CITY LINK TRUCKING

Construction Drawings

PCD FILE NO. PPR2339

TITLE SHEET

EROSION CONTROL DETAILS

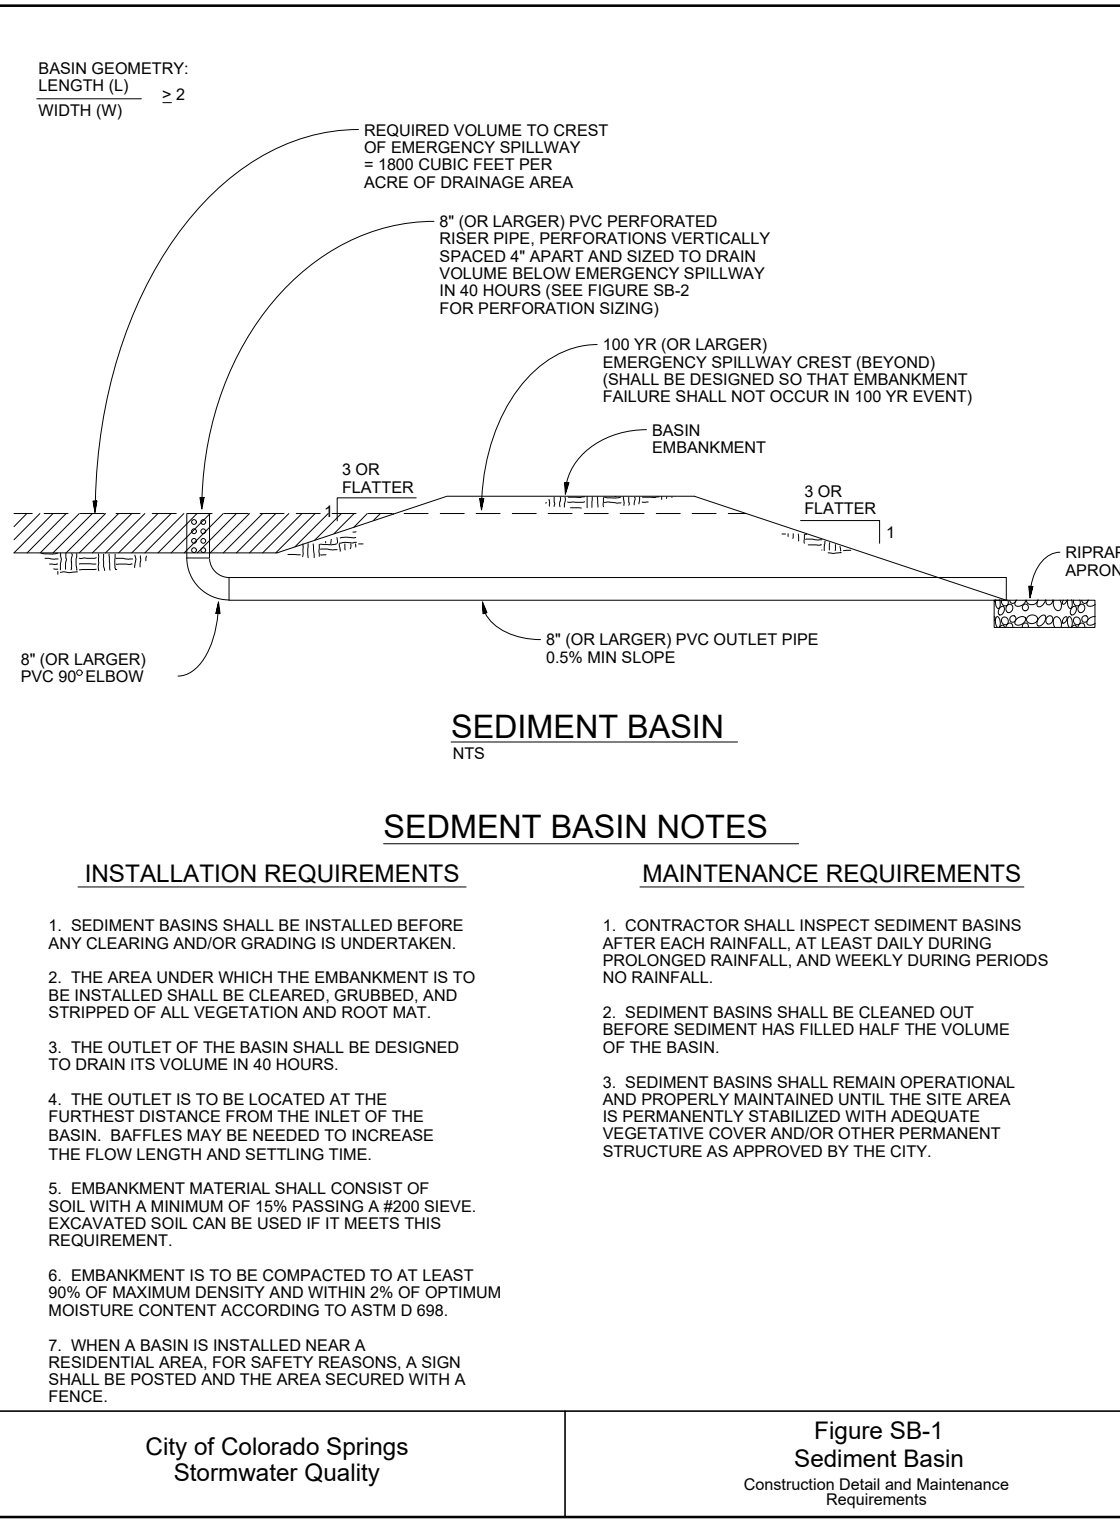
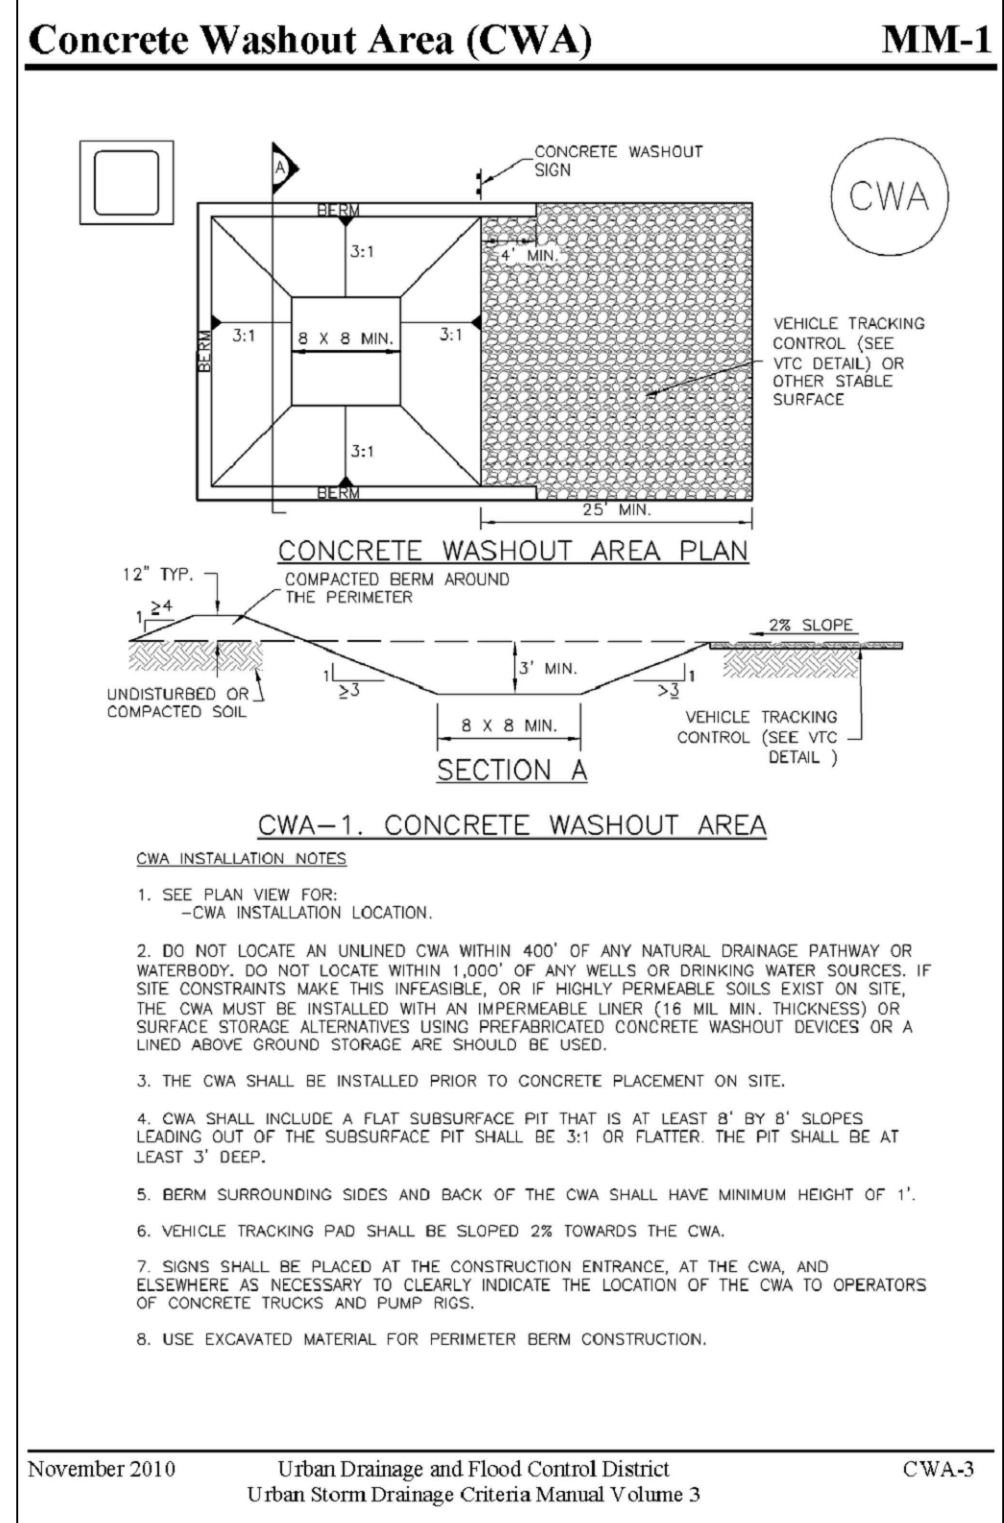
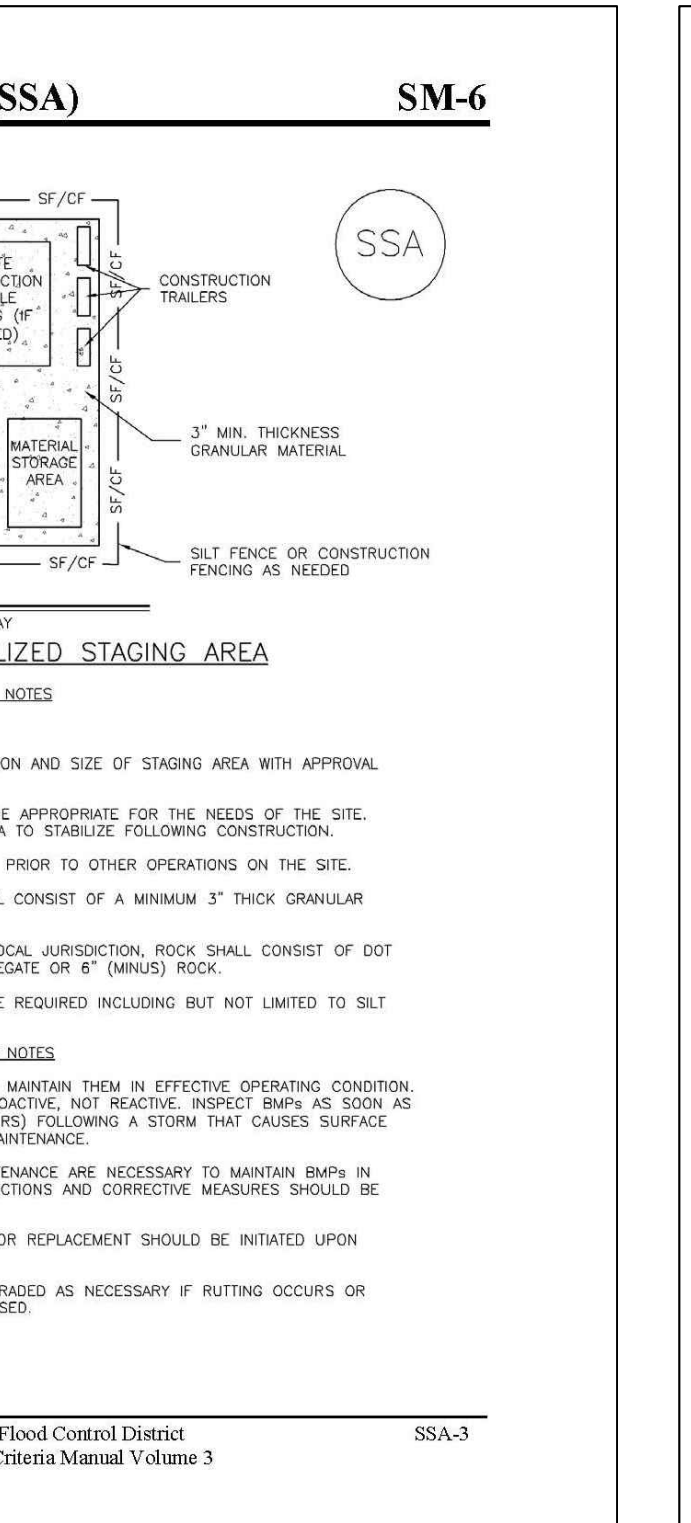
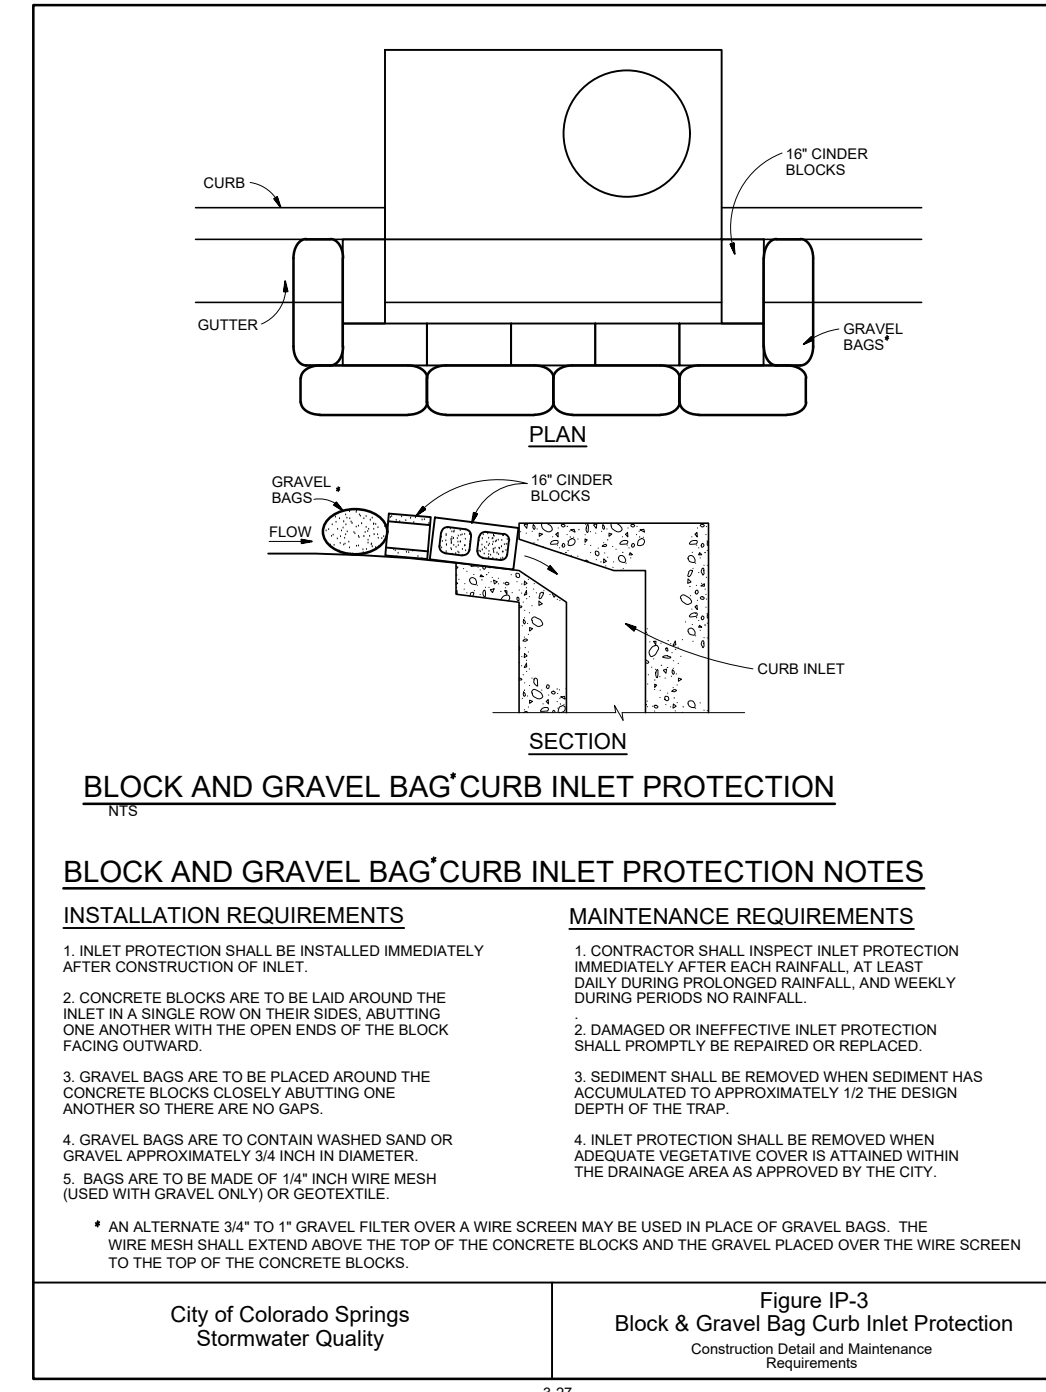
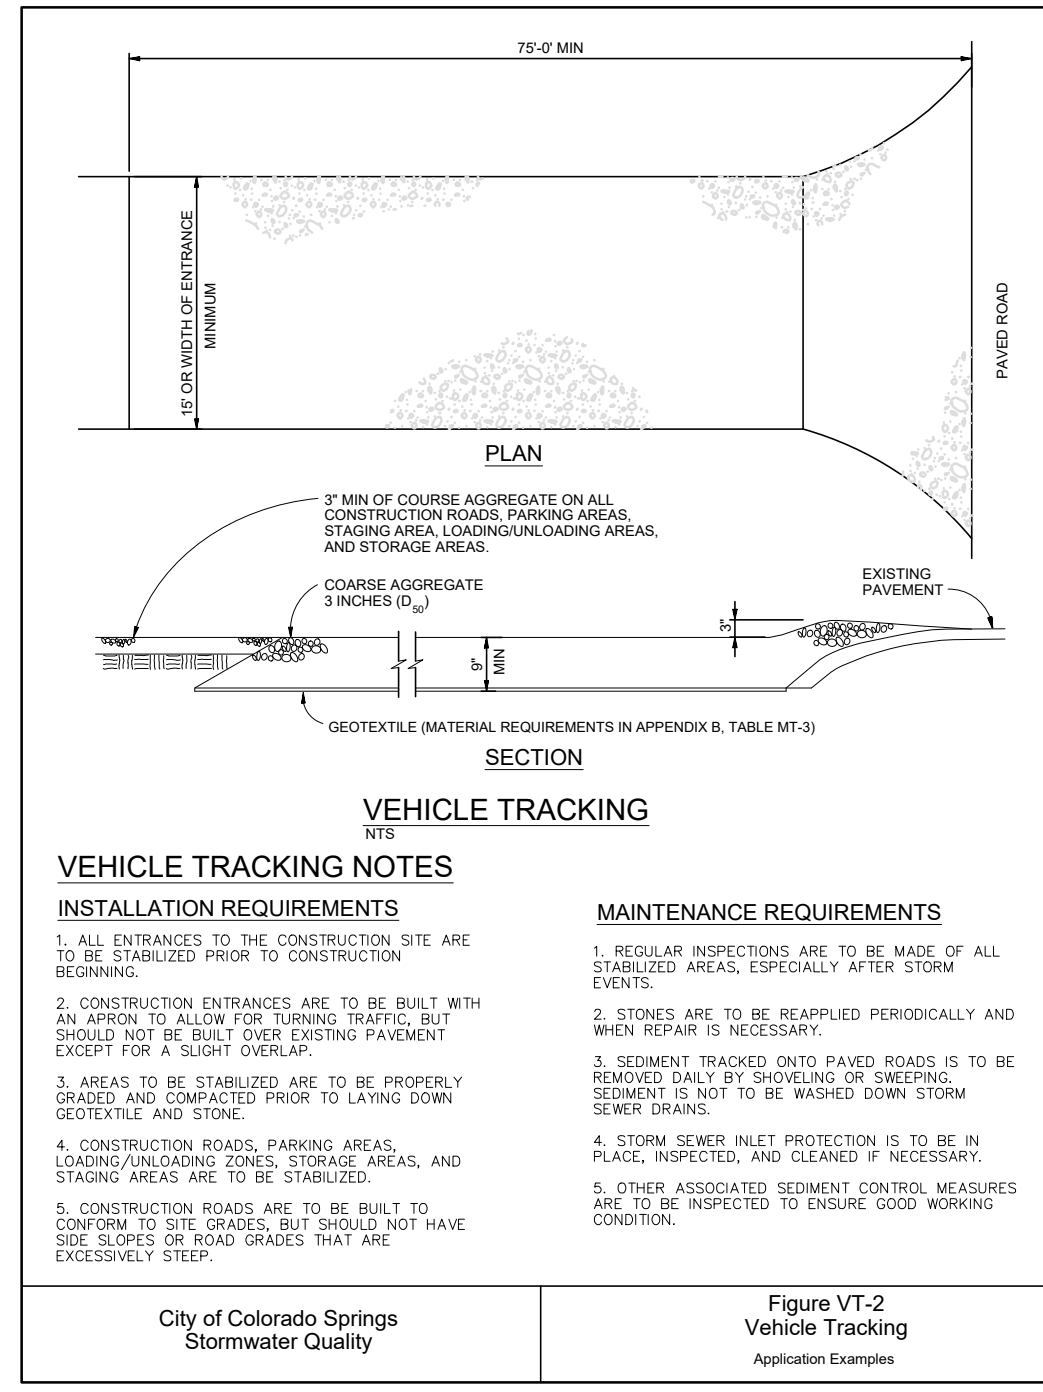
This is not a full detail for the TSB. Verify if this is an old detail. The current TSB detail on the Cities website shows grading and other details as well as providing tables. Up to date details should be used.
